Re: Philip Lovato & Sons
4101 4th St NW
Request Permanent C.O. - Accepted
Engineer's Stamp dated: 7-6-14 (G14D085)
Certification dated: 9-22-14

Project Title: LOVATO, PHILIP & SONS 4101 4TH ST Building Permit #: _____ City Drainage #: 614D085

**RE: Philip Lovato & Sons 4101 4th St NW
Grading and Drainage Plan
Engineers Stamp Date 6/30/14 (G14-D085)**

RE: **Philip Lovato & Sons 4101 4th St NW**
Grading and Drainage Plan
Engineers Stamp Date 2/16/14 (G14-D085)

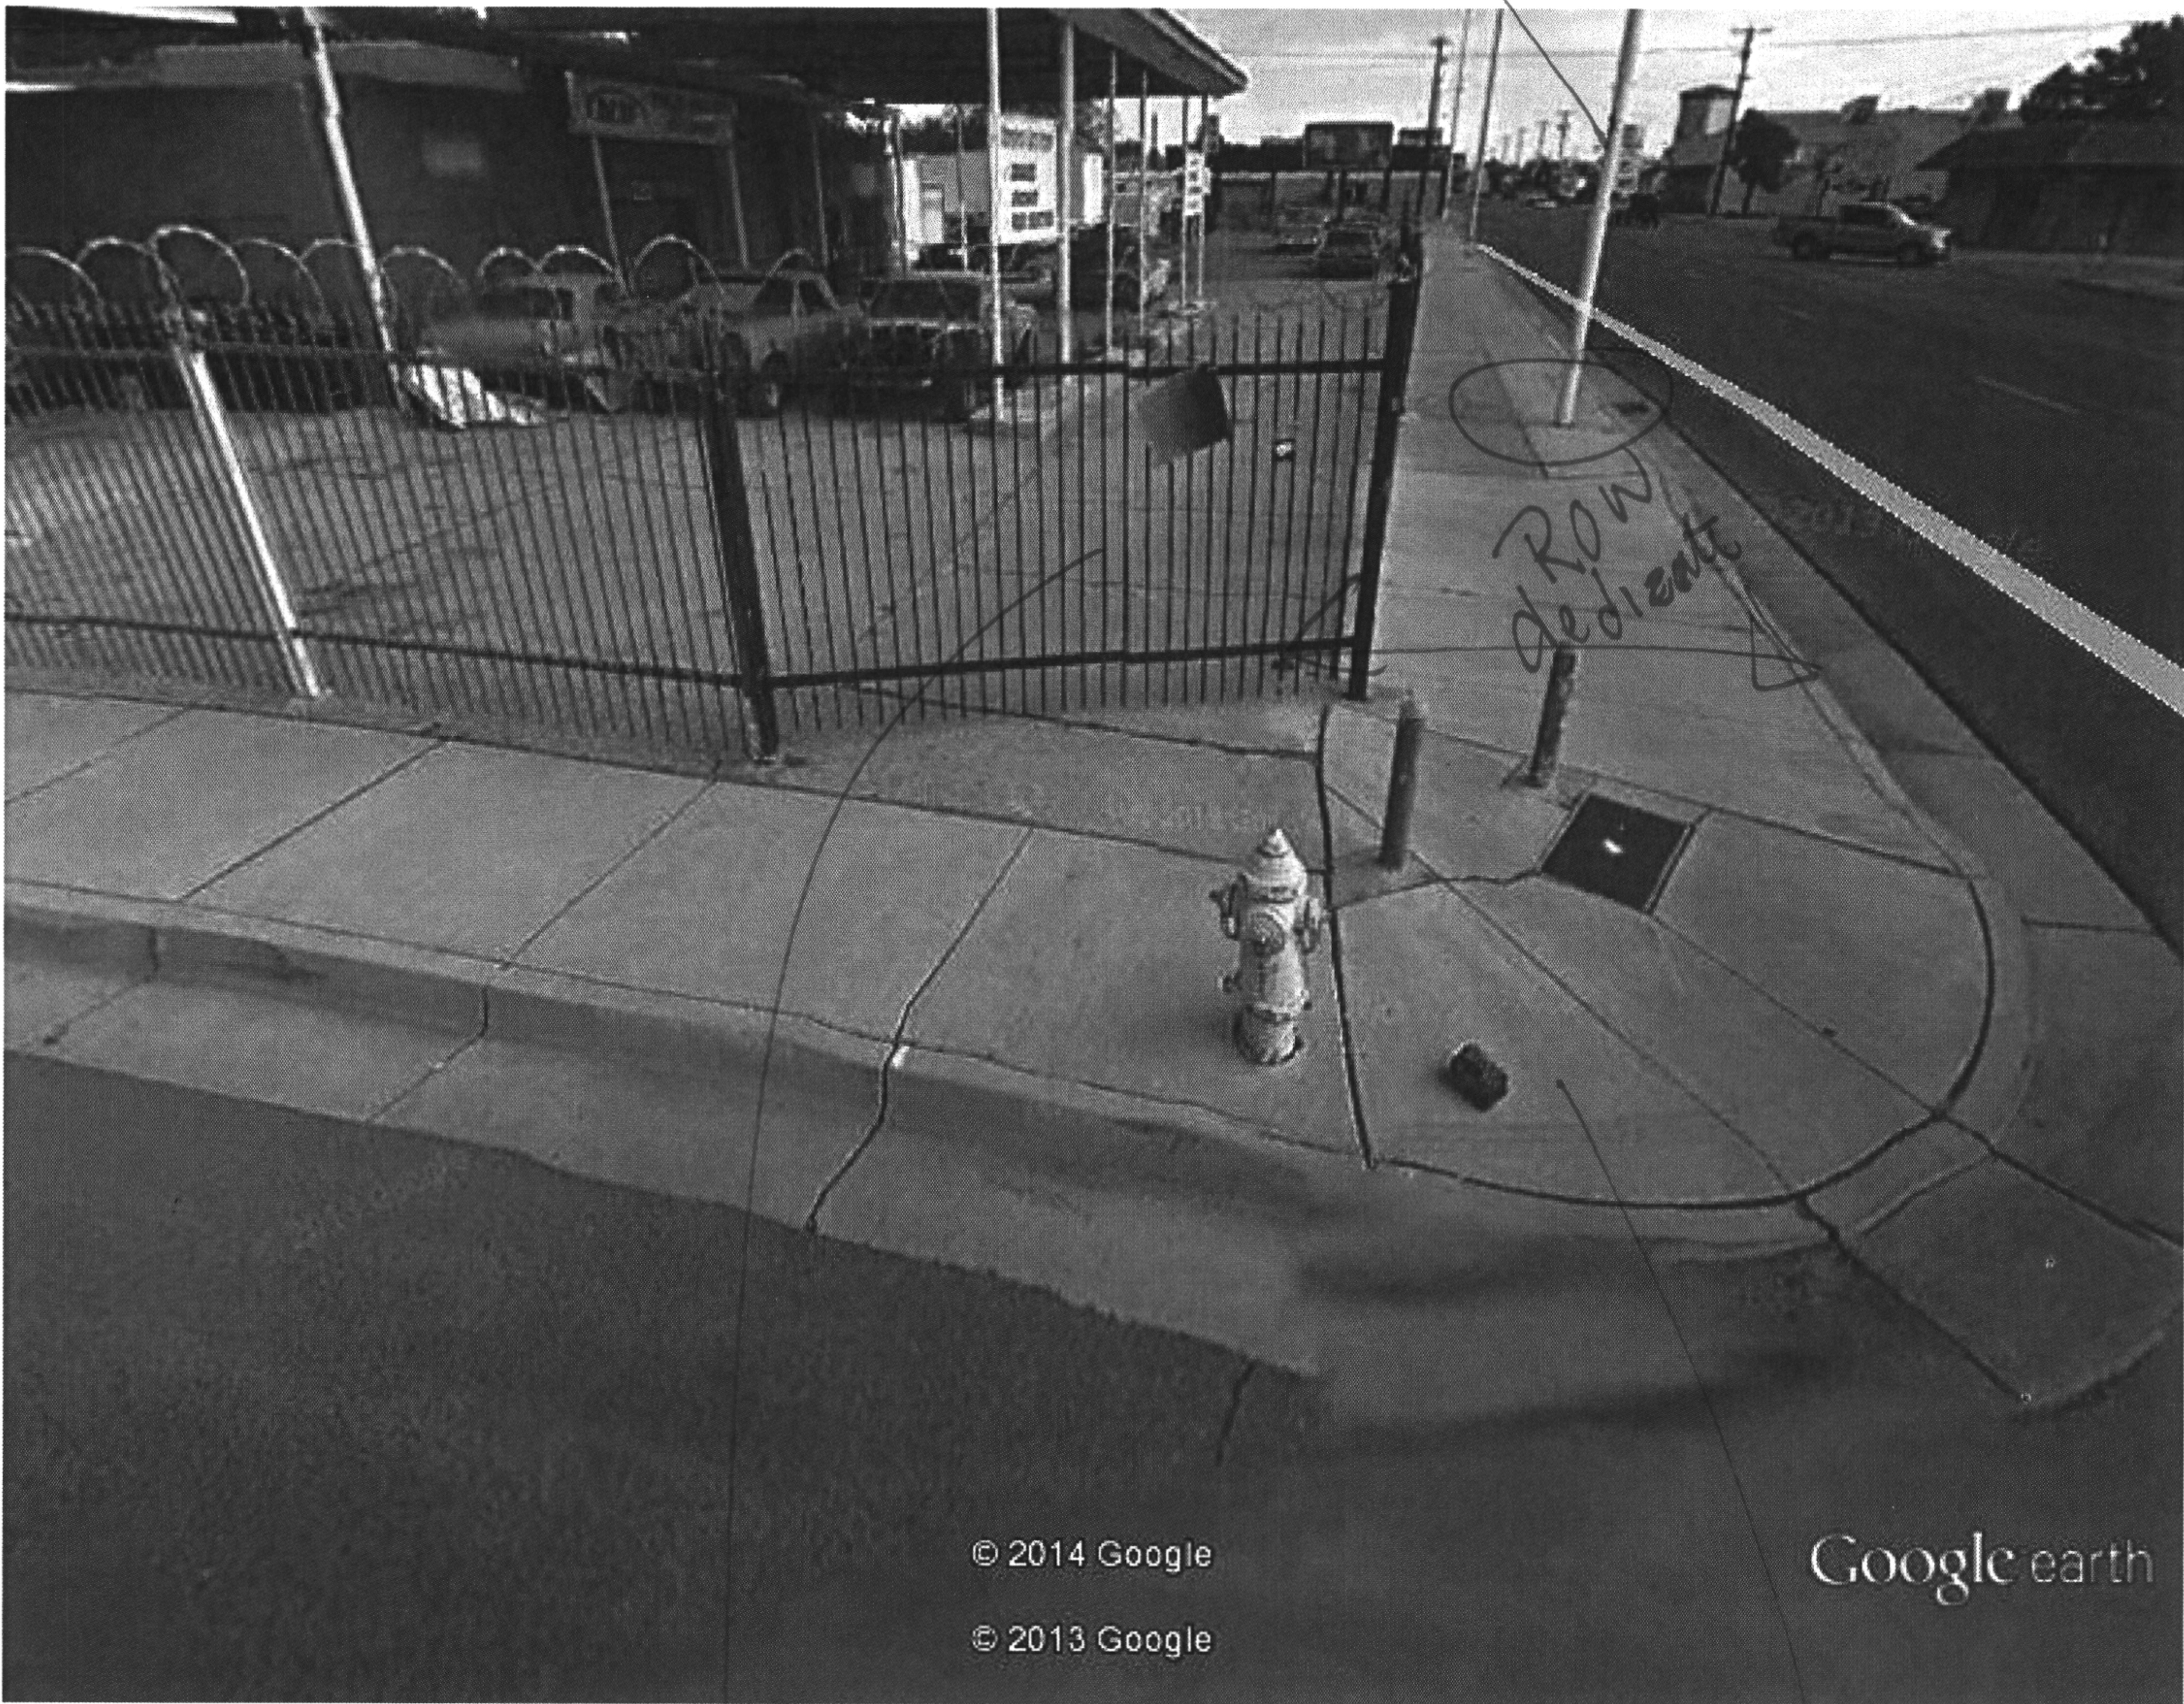
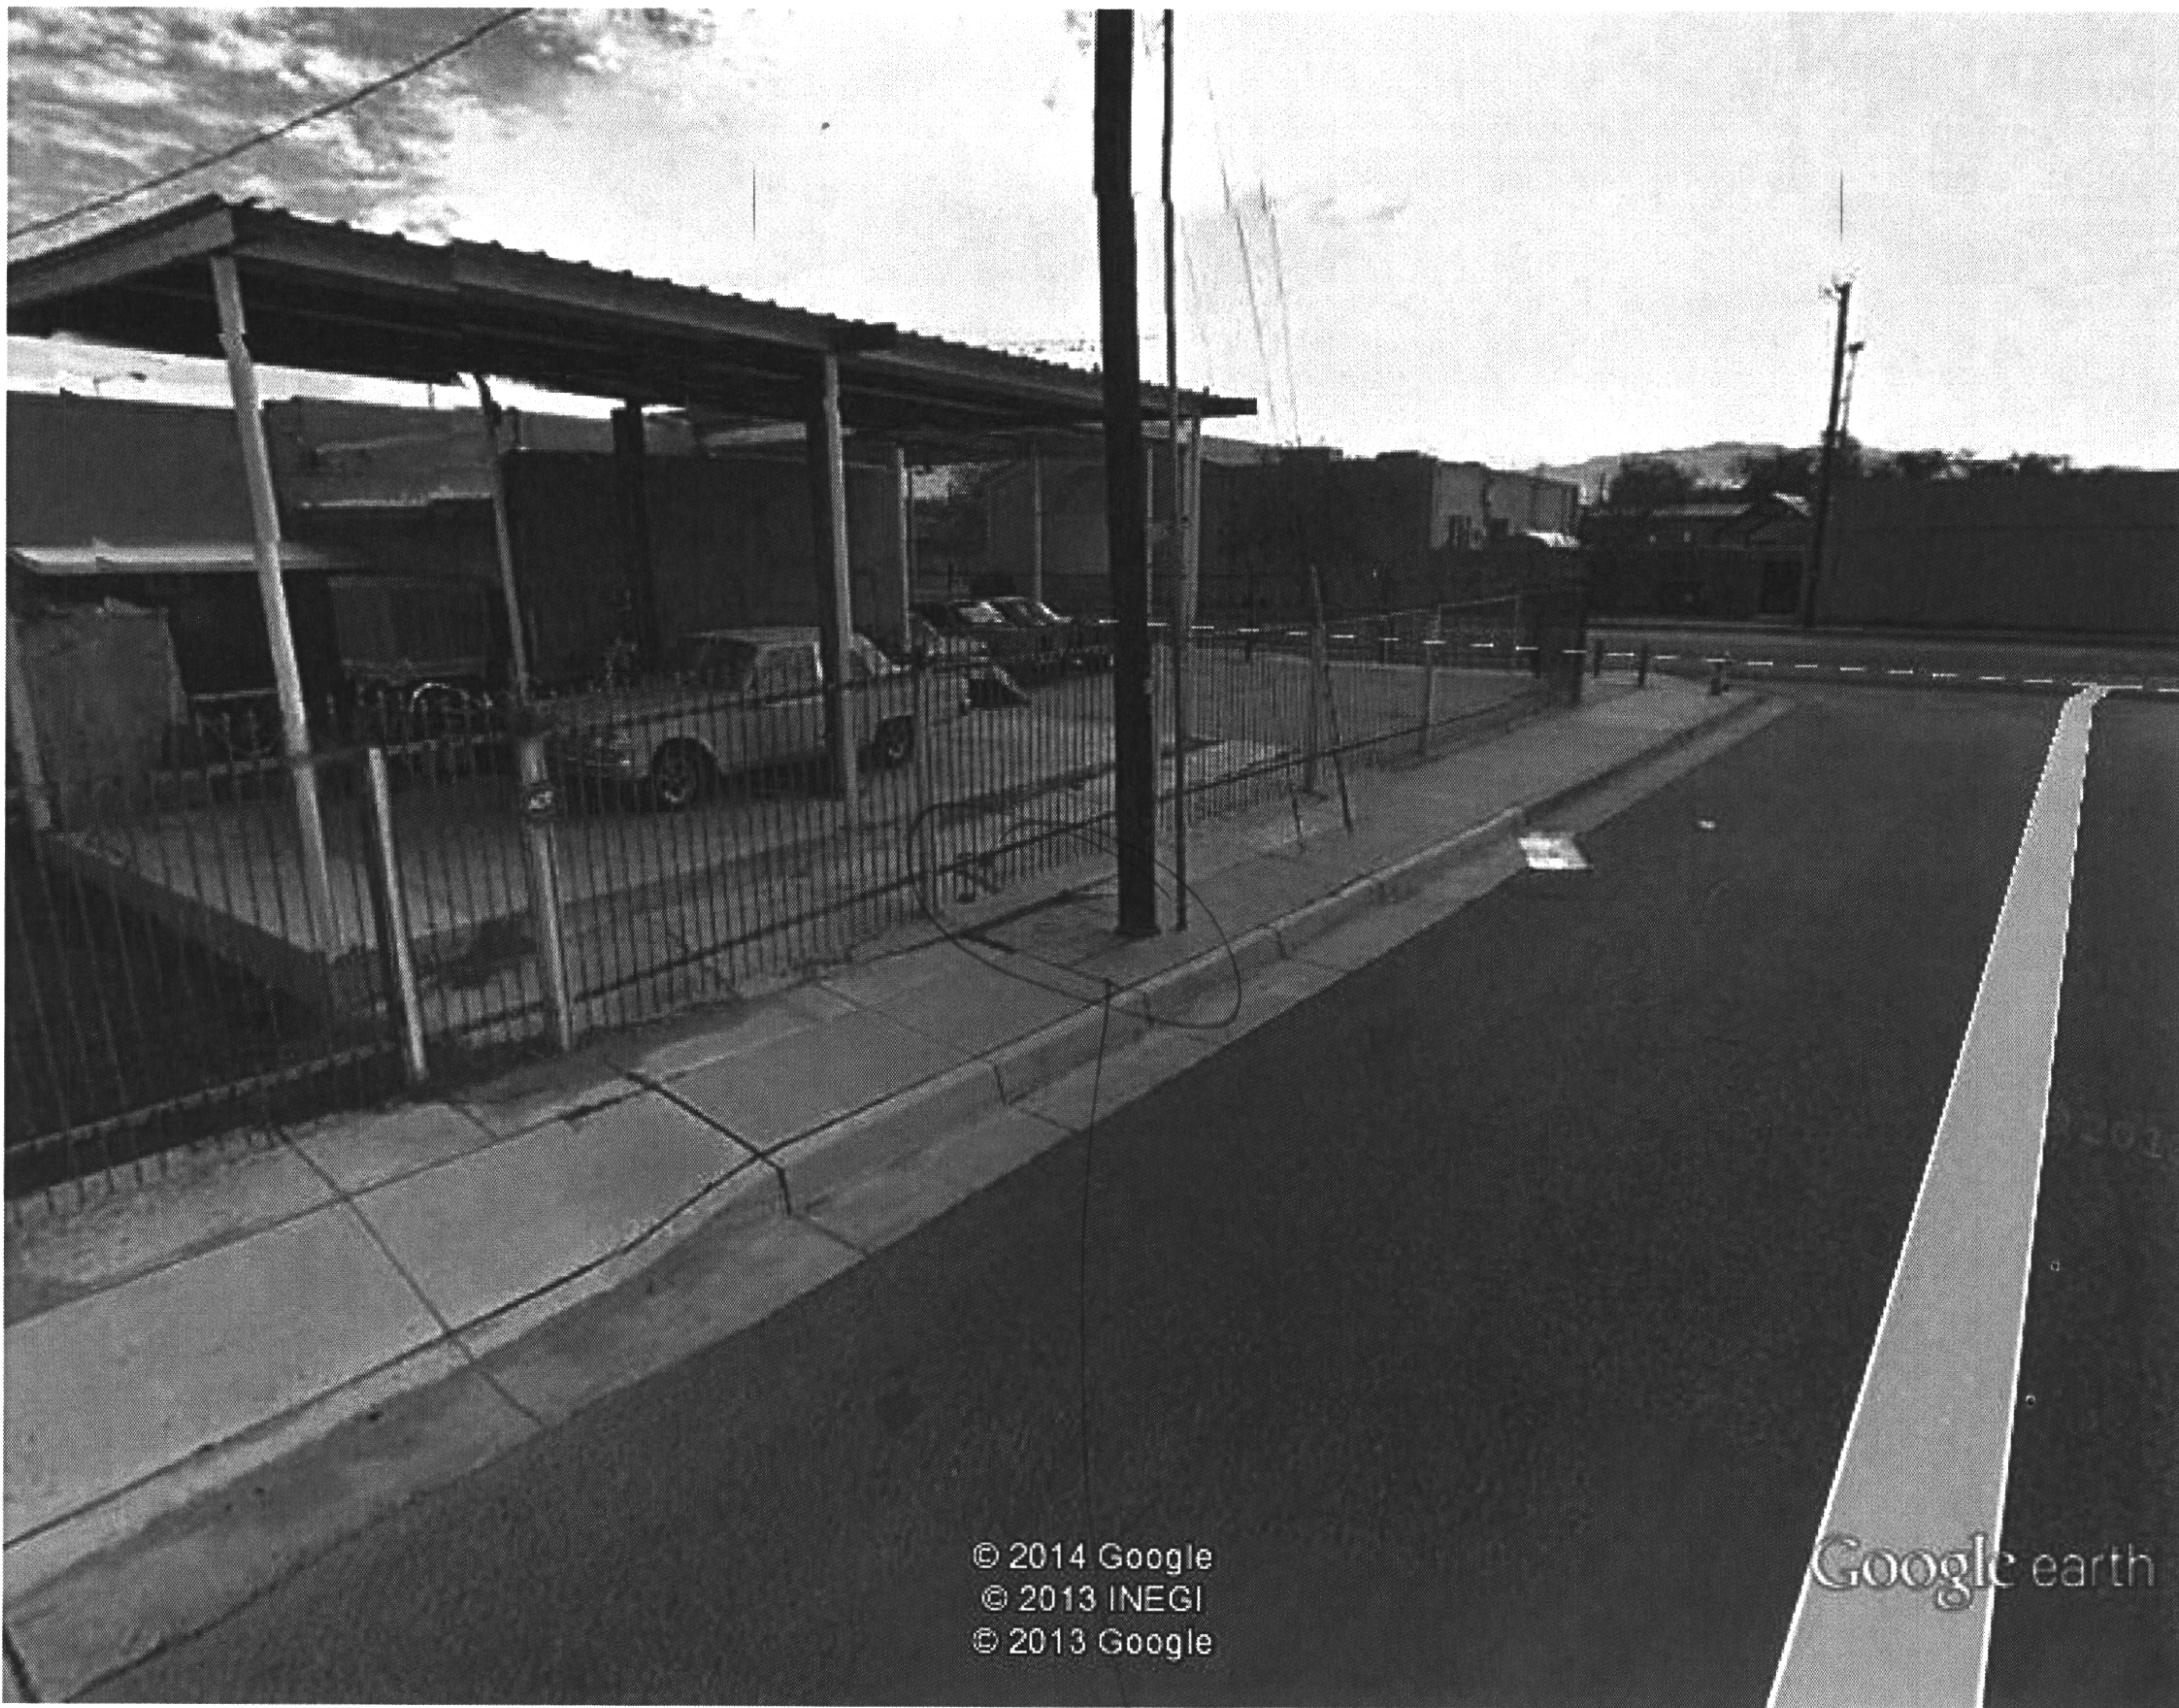
Visual issue?

ADA?
